## RB139-06/07

### R401.1, 401.2, Table R401.1 (New)

*Proposed Change as Submitted:*

**FIGURE R403.4(1)**  
**BASEMENT OR CRAWL SPACE WITH PRECAST FOUNDATION WALL BEARING ON CRUSHED STONE**

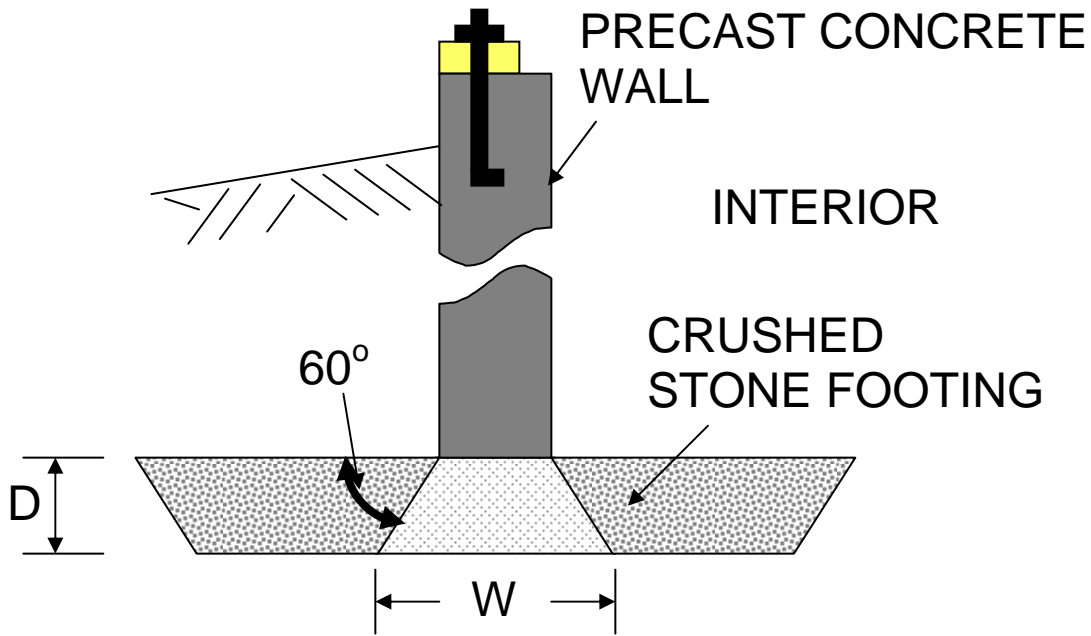
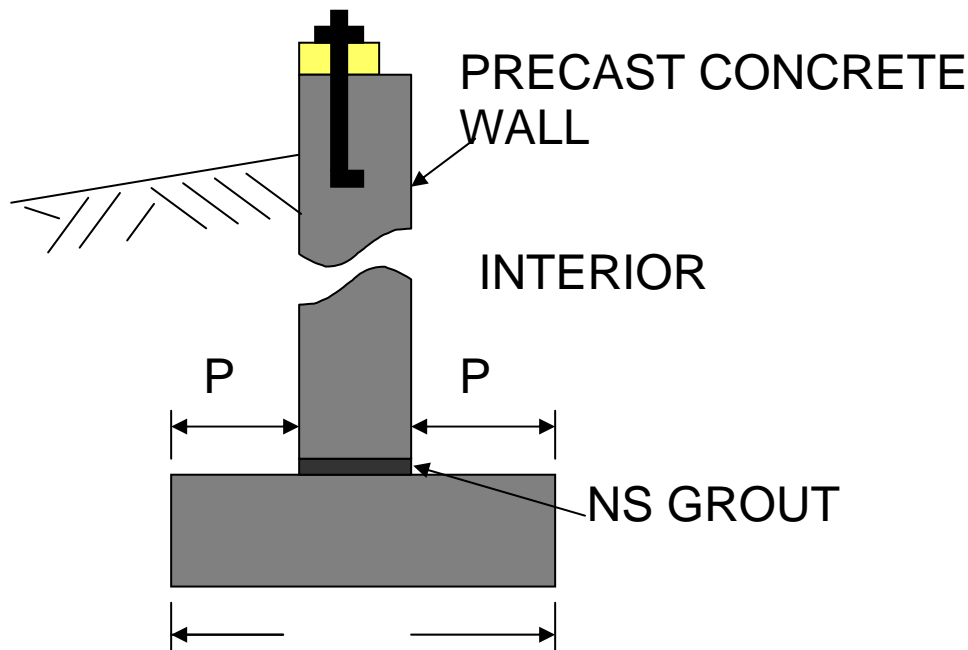
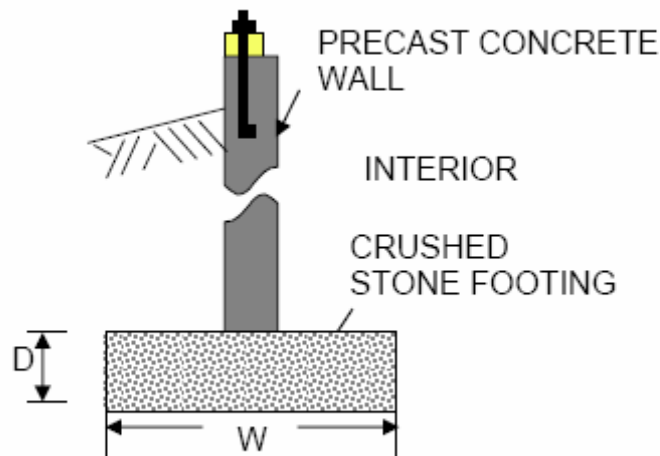
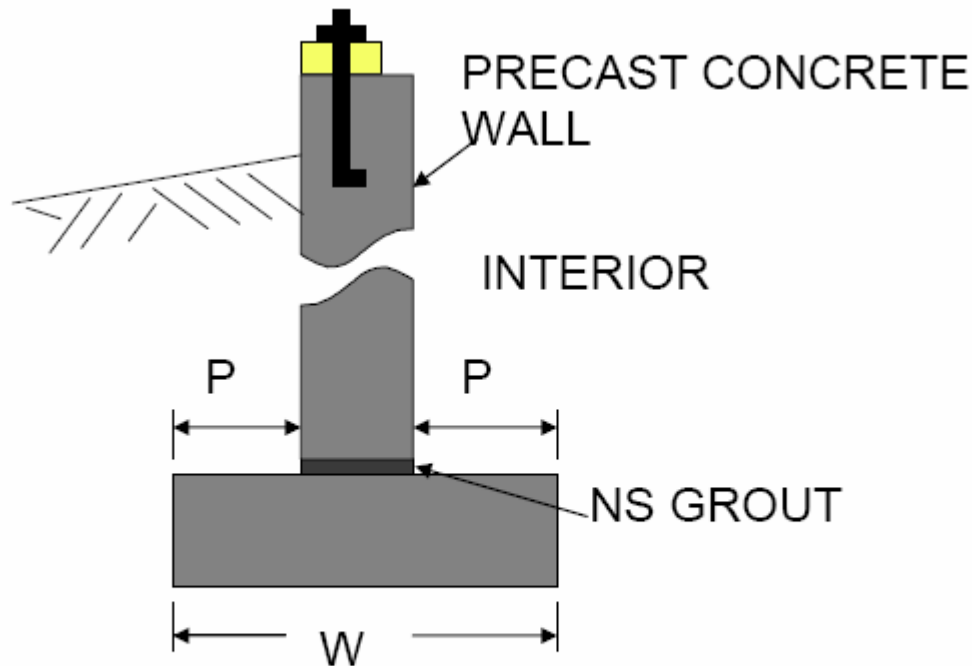
**R403.4.1 Crushed Stone Footings.** Clean crushed stone shall have a maximum size of 1/2 inch (12.7 mm). Crushed stone footings for precast foundations shall be installed in accordance with Figure R403.4 (1) and Table R403.4 (1). Crushed stone footings shall be consolidated using a vibratory plate in a maximum of eight-inch lifts.

**R403.4.2 Concrete Footings.** Concrete footings shall be installed in accordance with Section 403.1 and Figure R403.4 (2).

**Commenter's Reason:** Crushed stone and gravel footings are permitted by the IRC (Section R403.2) for wood foundations and have been used for years by both wood foundations and precast concrete foundation systems. However, the information for precast concrete foundation systems is not in the IRC. This submission will provide clarity for the building official including tables for appropriate depth of footings and figures to illustrate proper installation. The submission was modified to address the committees concerns about seismic applications. Section R301.2.2 notes that "seismic provisions of this code shall apply to buildings constructed in Seismic Design Categories C, D<sub>0</sub>, D<sub>1</sub> and D<sub>2</sub>, thereby exempting Seismic Design Categories A & B. Furthermore, the exception notes that "detached one- and two-family dwellings located in Seismic Design Category C are exempt.

**R403.4.1 Crushed Stone Footings.** Clean crushed stone shall ~~have a maximum size of ½ inch (12.7 mm)~~ be free from organic, clayey or silty soils. Crushed stone shall be angular in nature and meet ASTM C 33, with the maximum size stone not to exceed ½ inch (12.7 mm) and the minimum stone size not to be smaller than 1/16-inch (1.6 mm). Crushed stone footings for precast foundations shall be installed in accordance with Figure R403.4 (1) and Table R403.4 (1). Crushed stone footings shall be consolidated using a vibratory plate in a maximum of eight-inch lifts. Crushed stone footings shall be limited to Seismic Design Categories A, B, and C.

**FIGURE R403.1.3.2  
DOWELS FOR SLABS-ON-GROUND WITH TURNED-DOWN FOOTINGS**

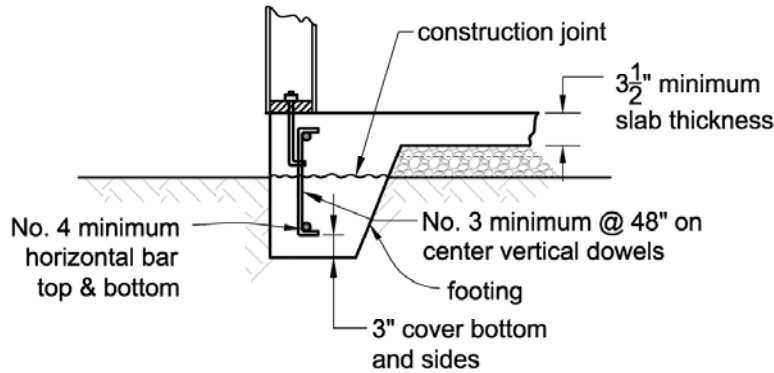
**Reason:** The exception is revised because placement of the reinforcing at the top and bottom of the footing provides much better crack control and stiffness and should always be an option. The addition of vertical dowels in slabs cast separately is in response to observation of wide-spread damage due to slippage on the construction joint during the 1994 Northridge Earthquake.

**Committee Reason:** The exception allows the reinforcement to be in the middle third of the footing depth. There is a question whether the No. 3 dowel at 4 feet on center is adequate.

The code development committee questioned whether the capacity provided by the dowels would be adequate. Using shear friction principles in accordance with ACI 318-05, the vertical dowels are adequate to carry an ASD horizontal shear of approximately 520 plf for grade 60 reinforcing and 350 for grade 40. This capacity should be adequate for direct shear and shear for flexural development.

Where the slab is not cast monolithically with the footing, No. 3 or larger vertical dowels with standard hooks each end shall be provided in accordance with Figure R403.1.3.2. Standard hooks shall comply with Section R611.7.1.5.

Fig. 2-12 Truck weight equivalent to hillside earth force.

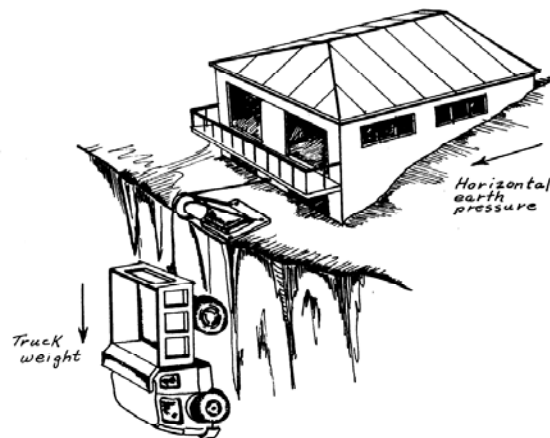
An additional problem is daylight basements. These load the structural system of the house to a much greater degree than an ordinary basement. The load has to be transferred from the endwall, through the floor diaphragm, to the side walls. The attachments become critical, and often undersized unless an engineer has been involved.

Sequist notes numerous failures and problems with daylight basements, and treats them in a separate chapter than the unrestrained wall failures. To understand the magnitude of the problem, he runs the calculation and shows that for a typical daylight basement, the lateral load that needs to be transferred through the house structure is about as large as the largest truck weight on the highway (about 40 tons).

**FIGURE R502.2.2  
DECK ATTACHMENT FOR LATERAL LOADS**

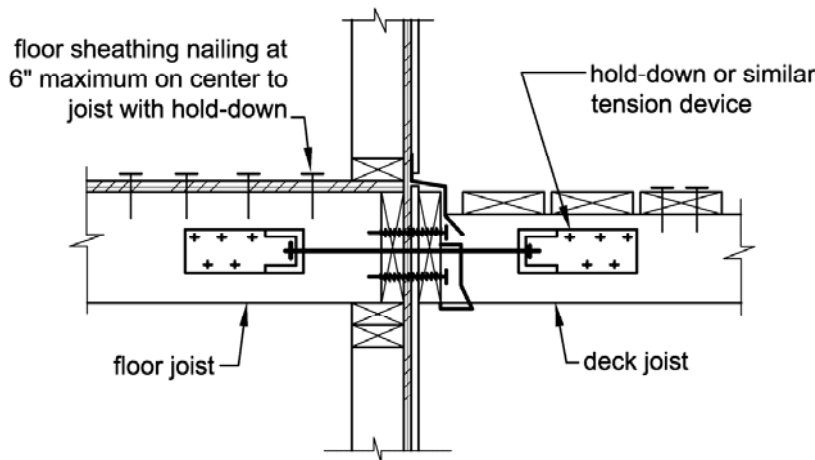
**R502.2.2.2 Deck lateral load connection.** The lateral load connection required by Section R502.2.2 shall be permitted to be in accordance with Figure R502.2.2. Hold-down tension devices shall be provided in not less than two locations per deck, and each device shall have an allowable stress design capacity of not less than 1500 lb.
